Hummingbird Energy LLC
Second Set of Supplemental Responses to Siting Board Staff's First Request for Information
Case No. 2022-00272

HUMMINGBIRD SOLAR PROJECT

Title
CONCEPTUAL LAYOUT
OVERALL SITE

Drawing No.
C100

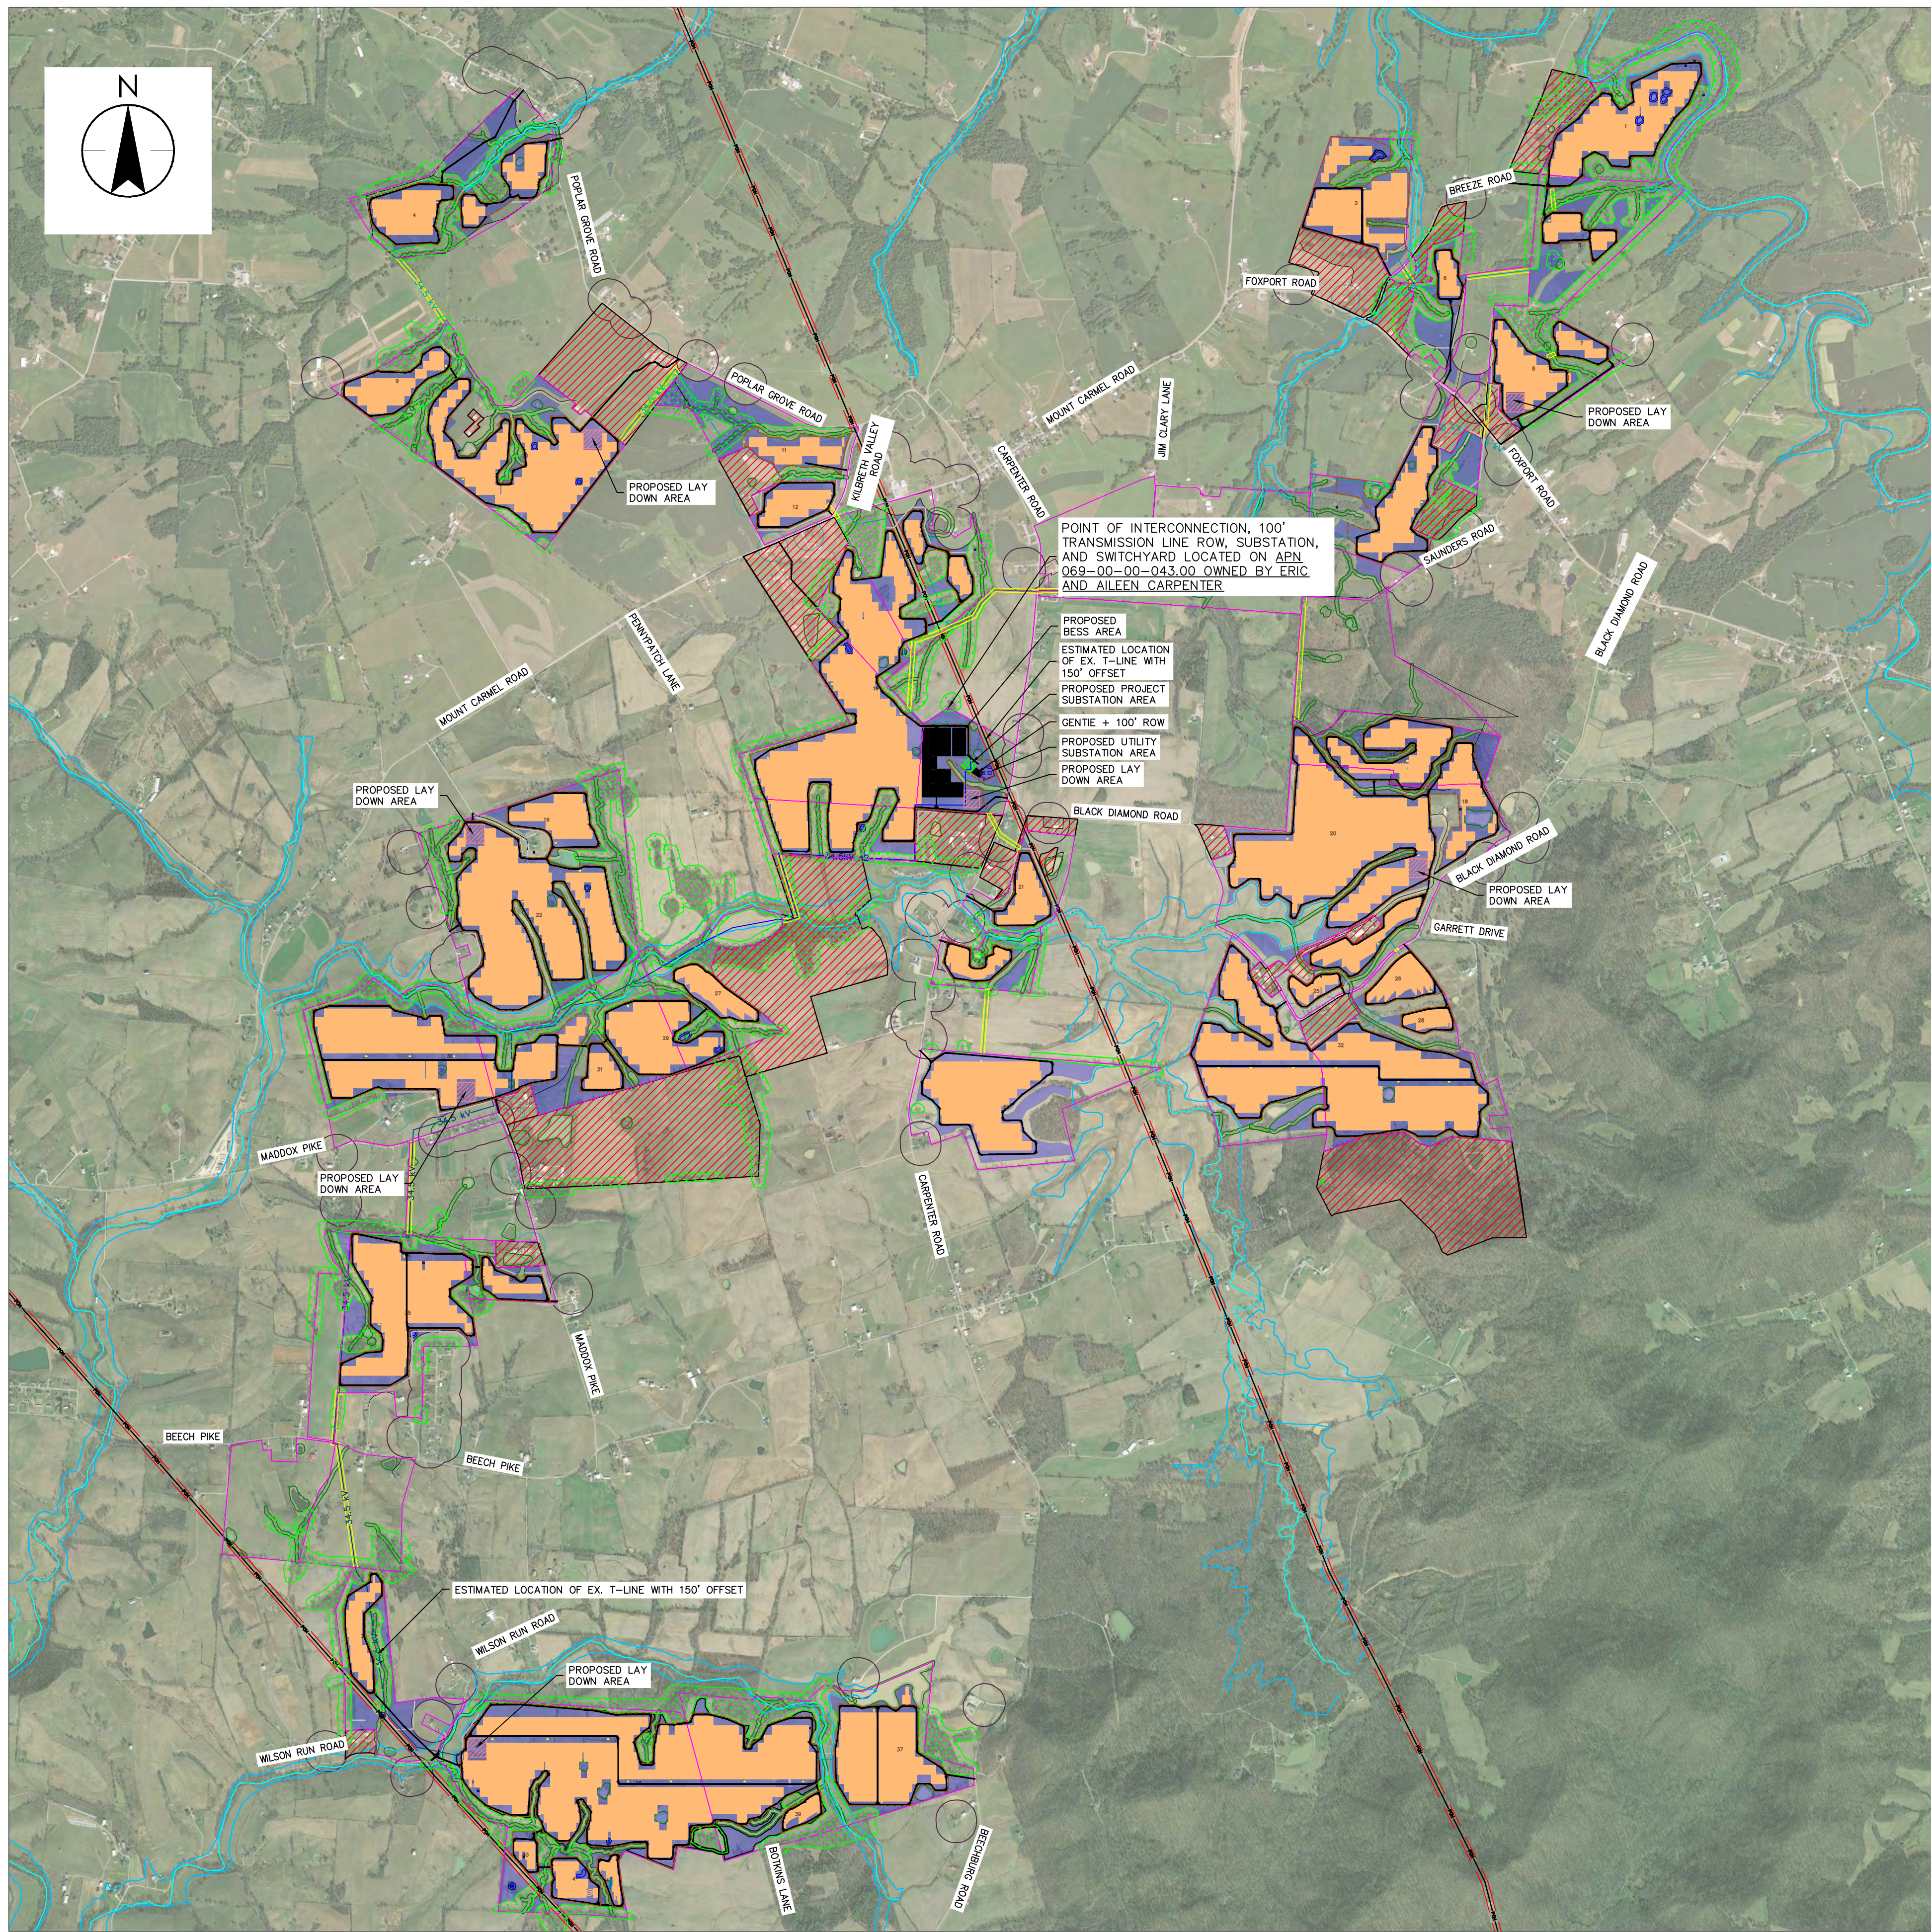
Refer to SAR, Exhibit A (Project Site Maps). State whether the proposed access roads referred to in the legend as thick orange lines are marked by thick black lines on the site maps. If not, identify on a map the locations of the proposed access roads.

List of Changes to C100

- Legend changed to show access roads as black.
- Existing access road extended to touch Poplar Grove Road.
- Easement corridor added near Kilbreth Valley Road.
- MV feeder line near POI reconfigured so as to not travel parallel with overhead T-Line.
- Karst areas near BESS and on parcel 069-0200 revised.
- Existing entrance road extended to touch Carpenter Road.
- Entrance road added that extends from Wilson Run Road to near the laydown road.

The proposed access roads are depicted as thick black lines.

After conducting the site visit and reviewing the relevant maps with Siting Board Staff and representatives of Harvey Economics, Hummingbird revised its Project Site Maps to clarify the locations of certain Project features, including proposed entrances and entrance roads. In addition, Hummingbird has revised its map depicting public resources within two miles of the Project to include two previously excluded cemeteries located approximately two miles from the Project's southeastern boundary, near Bowman Springs Road and John Lane. A complete list of changes made on each map is provided here:

Title
CONCEPTUAL LAYOUT
SECTIONAL VIEW

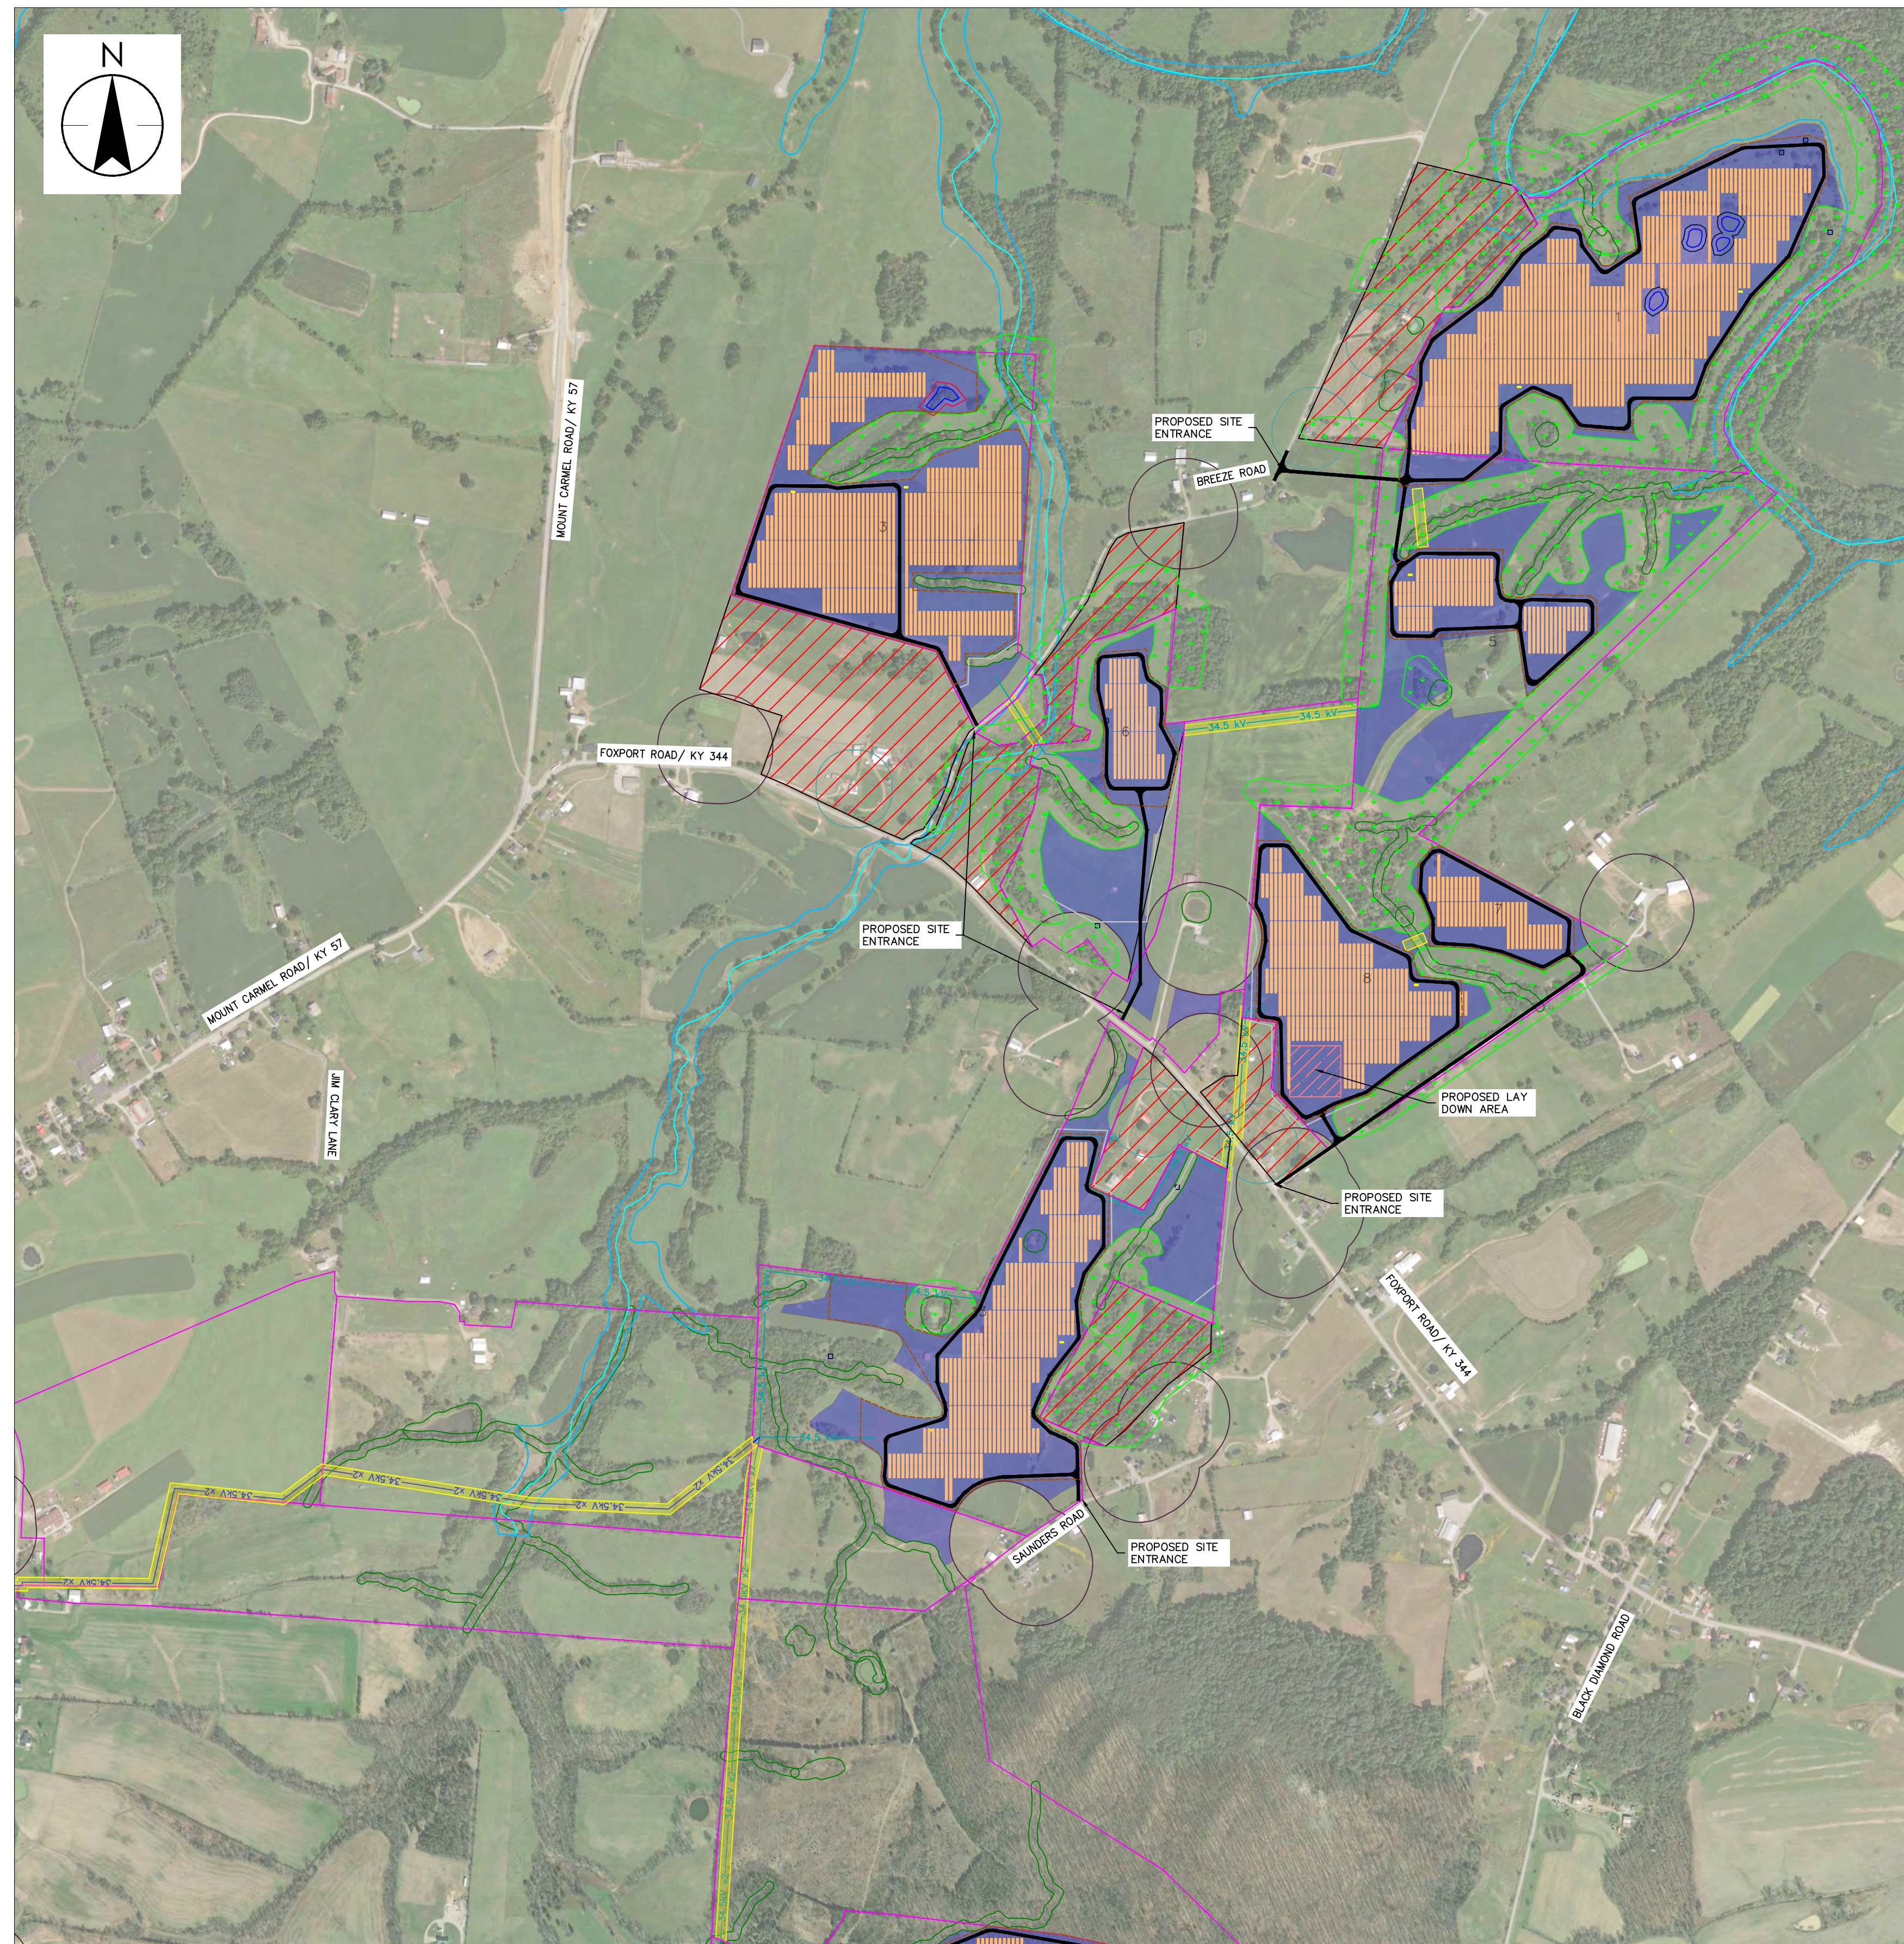
List of Changes to C200-1

- Existing entrance road extended west so it merges with Breeze Road, label relocated.
